Agenda Item: Recommend Approval of Final Plat (Delaware Place Development)
Recommend Approval of Final Planned Unit Development (Delaware Place Development)

Re: Delaware Place Final PUD and Final Plat Site Plan Review

DELAWARE PLACE

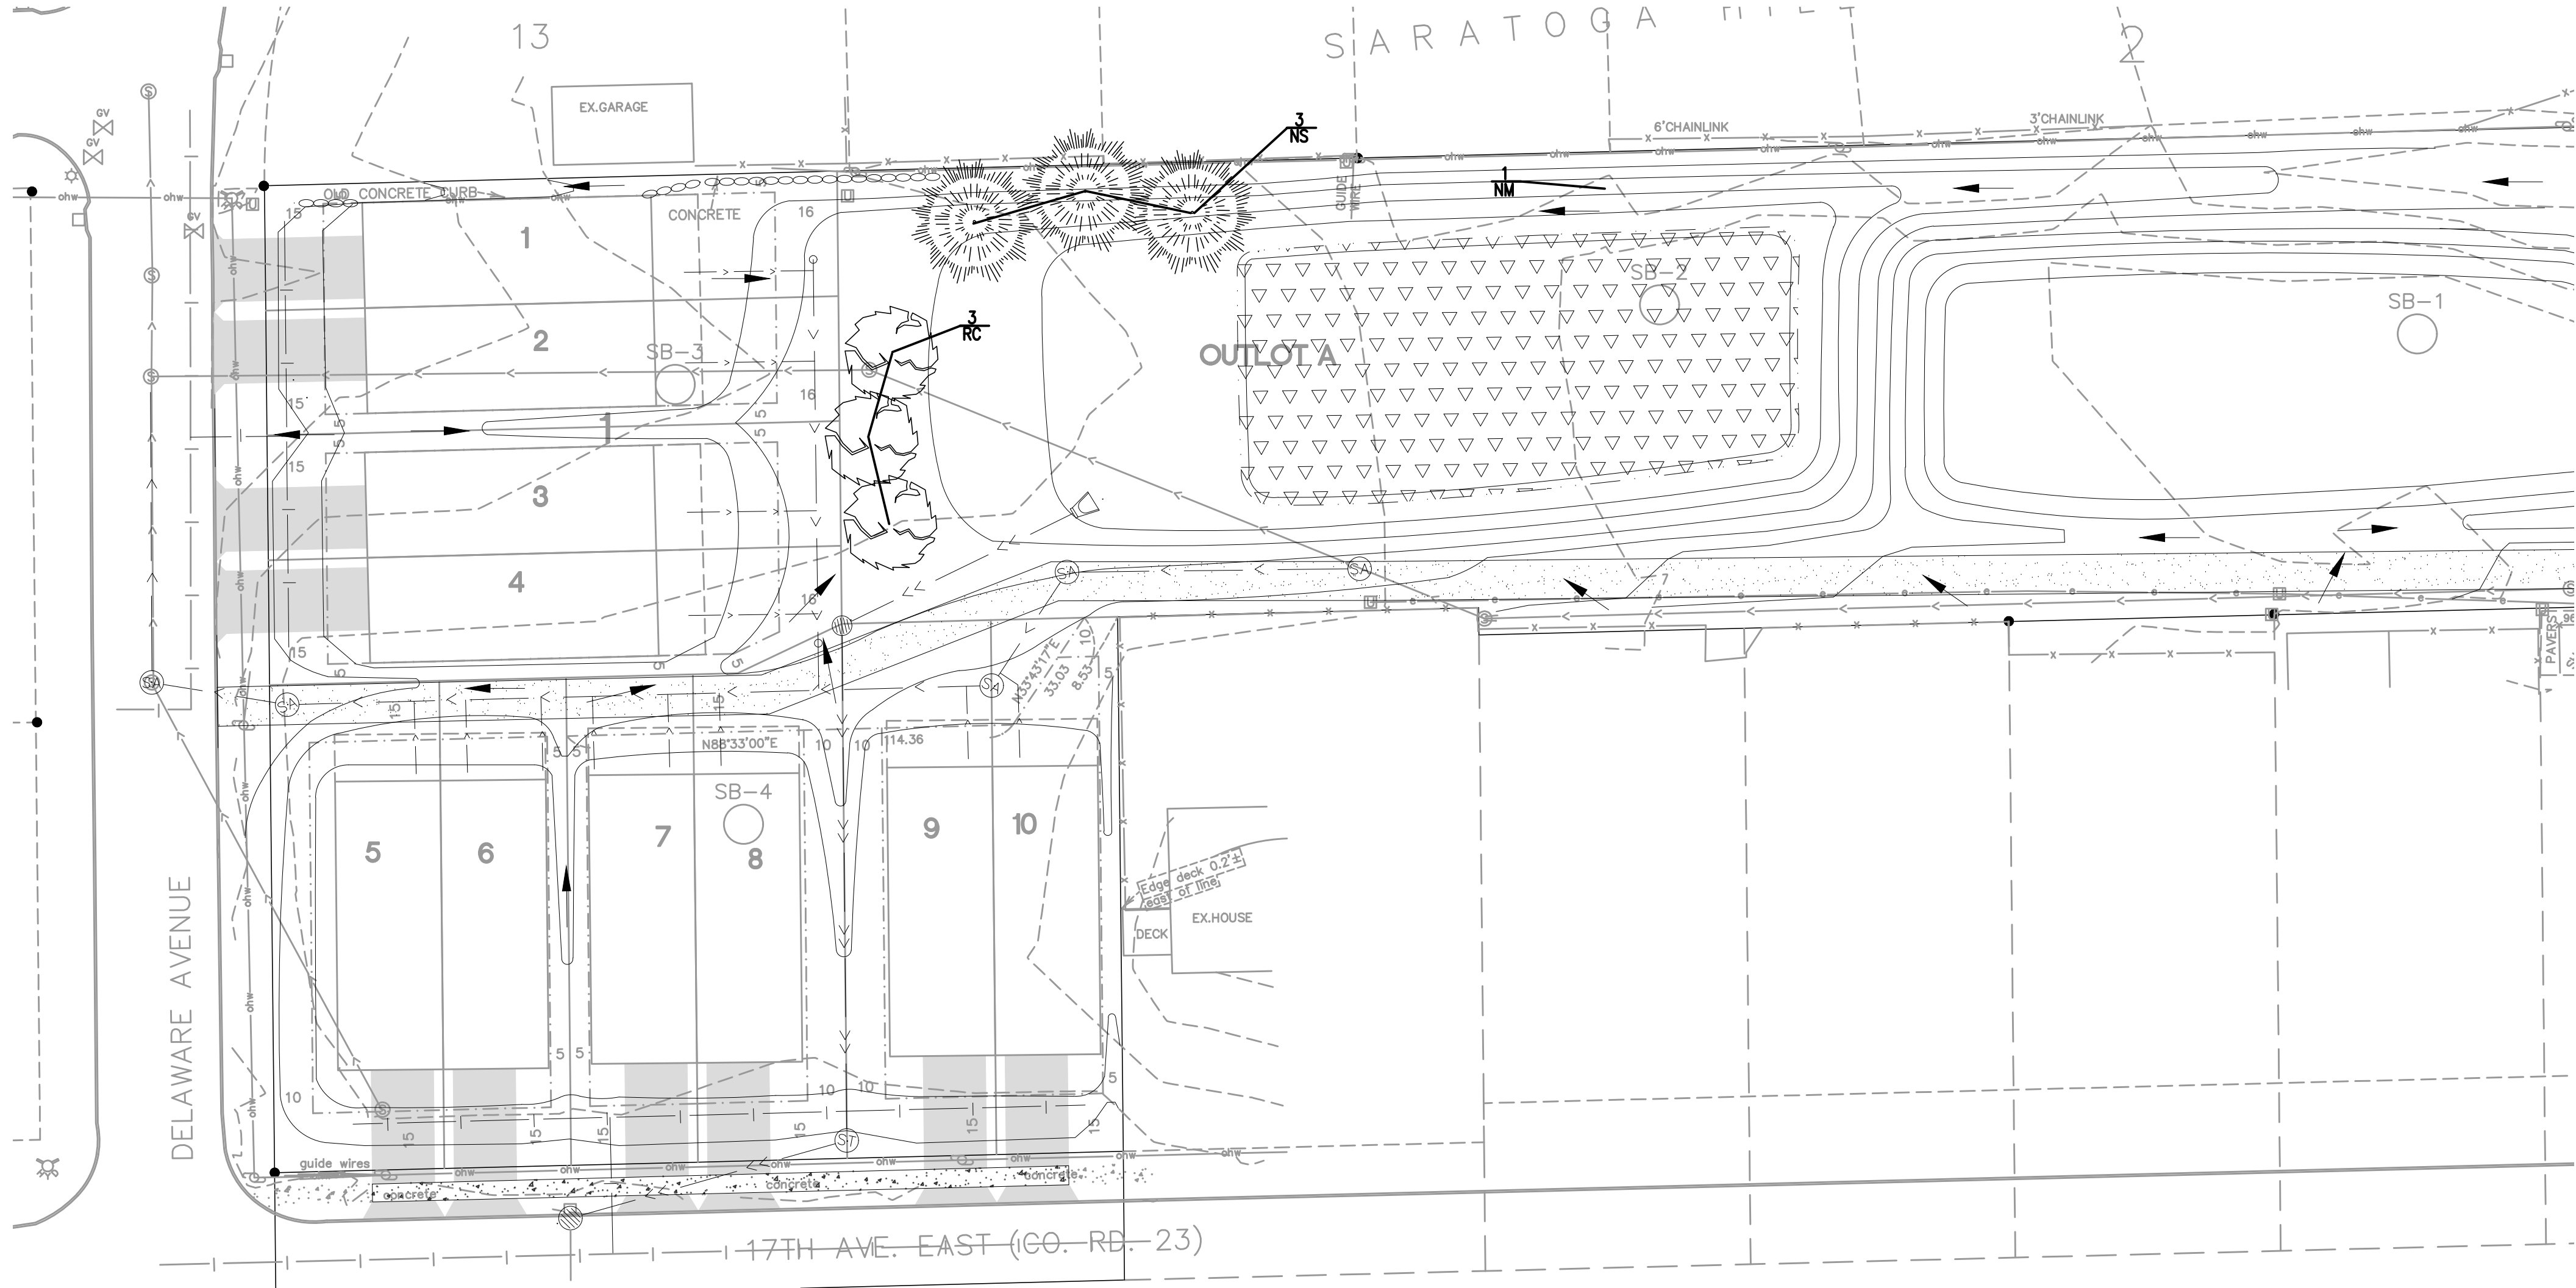
(F)9(a)	No landscape material other than grass, or retaining walls, shall be placed within a drainage, access or utility easement.	2 of the proposed trees are located within a drainage/utility easement.
(F)11.	Prior to the issuance of building permits for all new and/or expanded uses, a tree preservation plan shall be submitted.	There is only one existing tree on the site that will be removed and replaced as a result of development.

1. Any changes or deviations from the final landscaping plan shall not place trees, vegetation, or other landscaping within lot line drainage swales, emergency overflow routes, and over or within a 1:1 excavation trench for existing and proposed underground utilities.
